DOCKETED	
Docket Number:	25-BSTD-03
Project Title:	2028 Energy Code Pre-Rulemaking.
TN #:	271534
Document Title:	Improvements to Lighting Acceptance Testing for Luminaire Level Lighting Controls Final CASE Team Comment Letter
Description:	Final CASE Team Comment Letter - Improvements To Lighting Acceptance Testing For Luminaire Level Lighting Controls
Filer:	Michael Shewmaker
Organization:	California Energy Commission
Submitter Role:	Commission Staff
Submission Date:	7/17/2026 2:42:25 PM
Docketed Date:	7/17/2026

IMPROVEMENTS TO LIGHTING ACCEPTANCE TESTING FOR LUMINAIRE LEVEL LIGHTING CONTROLS

Docket No. 25-BSTD-03

Figure 4: Example of proposed reference location for individually controlled LLLCs

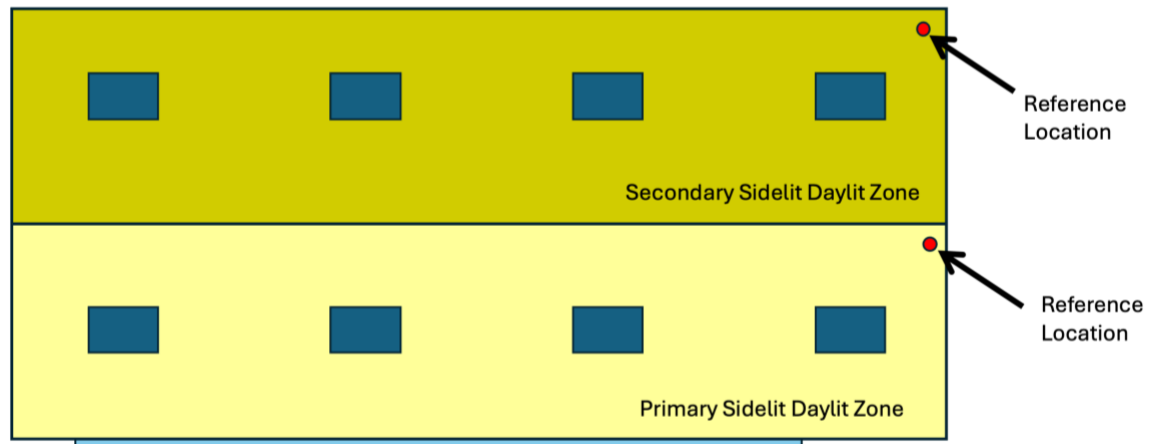
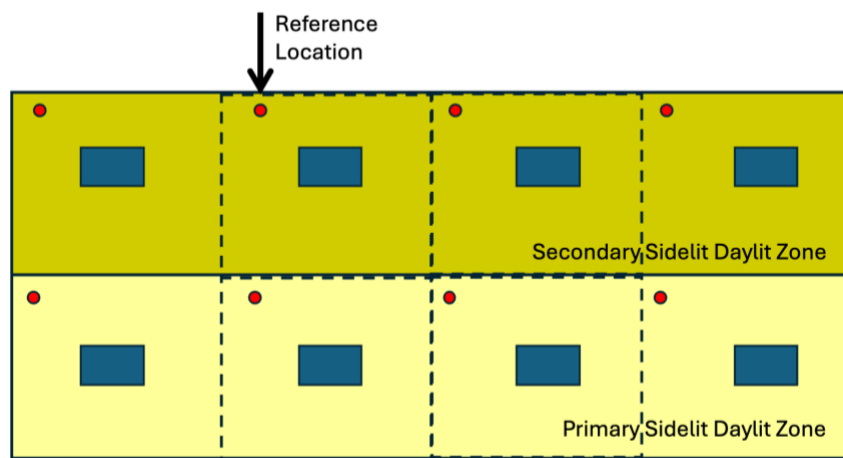
For individually controlled LLLCs, the ATT should choose a reference location relative to the daylit area of the individually controlled LLLC being tested. This will allow the ATT to use either the illuminance method or the distance method without modifying the existing procedure for determining the reference location.

Currently, the reference location is relative to the entire daylit area, which is designed for luminaires that are controlled in groups by non-LLLC systems or connected LLLC systems. The procedure of determining the reference location would not change whether there is a sensor on each luminaire or a separately mounted sensor controlling multiple luminaires. See the example provided in Figure 3. Note that the reference location in Figure 3 is provided for illustration purposes, and an ATT's choice of reference location may vary due to onsite factors.

By subdividing the daylit zone as shown in Figure 4, it allows for the reference location methodology to remain unchanged while allowing for testing of individually controlled LLLCs. Note that the reference location with respect to every individually controlled LLLC is shown in Figure 4 for illustration purposes. For functional testing using the allowed sampling approach in NA7.6.1.2, only selected luminaires within a sample group need to be tested; therefore, the ATT only needs to determine the reference locations relative to those tested luminaires.

- a) **Reference Location.** Identify the minimum daylight location in the controlled zone (Reference Location) for each daylight zone type (skylit, primary sidelit, and secondary sidelit) in the space. This can be identified using either the illuminance method or the distance method and will be used for illuminance measurements in subsequent tests. For parking garages, the reference location should always be the farthest edge of the secondary sidelit daylight zone away from the opening or glazing. For individually controlled LLLCs, the controlled zone is determined by subdividing the daylight zone per LLC luminaire. The controlled zone is the area within the daylight zone that is primarily illuminated by the luminaire being tested.
